Transmitted by the expert from Germany

Proposal for 02 series of amendments to Regulation No. 66
(Strength of superstructure)

The text reproduced below is a revised version of ECE/TRANS/WP.29/GRSG/2009/5 The modifications to the current text of the Regulation are marked in bold or strikethrough characters. The changes to the text of ECE/TRANS/WP.29/GRSG/2009/5 are shown in red.

Annex 2, amend to read:

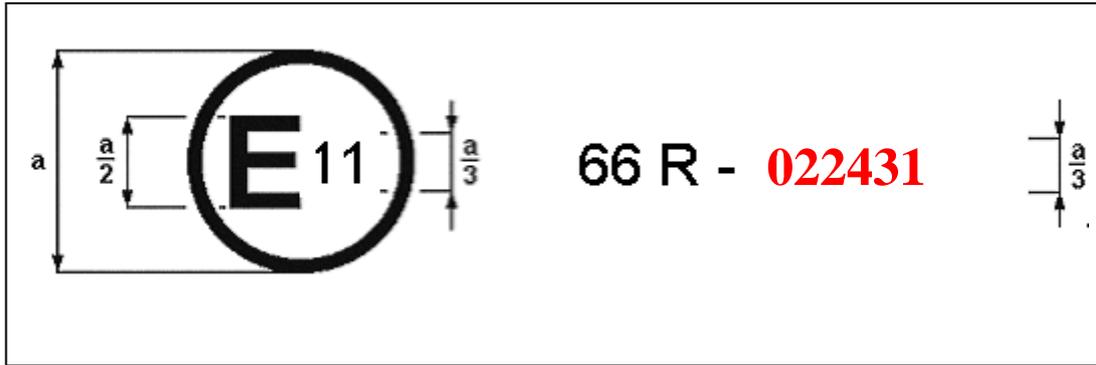
The above approval mark affixed to a vehicle shows that the vehicle type concerned has, with regard to the strength of the superstructure, been approved in the United Kingdom (E11) pursuant to Regulation No. 66 under approval number ~~012431~~**022431**. The first two digits of the approval number indicate that the approval was granted in accordance with the requirements of the **02** series of amendments to Regulation No. 66.
